01-22-03 - Late Production - Update Programming Engine/Motor Control Module -J623-

Release date: 1/9/2025

Revision Table			
Instance Number	Published Date	Version Number	Reason For Update
2066602/2	1/9/2025	01-22-03	To remove original part number and vendor in warranty table.
2066602/1	3/29/2022	01-22-03	Original publication.

Figure 1.

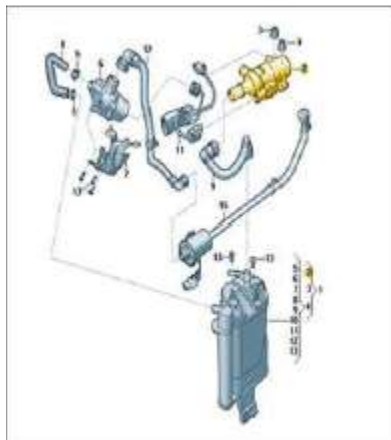
In addition to the software improvement, there is also an improvement to the FTIV (fuel tank isolation valve/tank switch-off valve -N288-) (Figure 1.), which is necessary in preventing erroneous occurrences of the P2421 fault code.

The FTIV / Tank switch-off valve -N288- currently installed on the vehicle must be inspected, to verify whether an improved part has already been installed. The FTIV / Tank switch-off valve -N288 is mounted to the EVAP canister assembly, as shown below.

Figure 2.

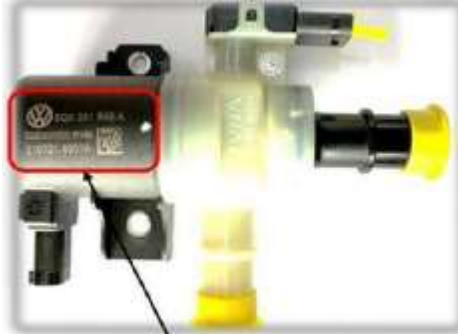
Remove the EVAP canister assembly and inspect the face of the FTIV / Tank switch-off valve -N288. If the part is already updated, it will have a white paint marking or "02S" printed after the part number, as shown in Figure 2 and Figure 3.

If the part has a white paint mark or "02S", the FTIV / Tank switch-off valve -N288- is already the updated component. In this case DO NOT replace it, and instead reinstall the EVAP canister assembly. Only the software update will be required.

If there is no white paint mark or "02S" are visible on the FTIV / Tank switch-off valve -N288, the component must also be replaced in addition to the software update. Always refer to ETKA for the most up to date part number information.
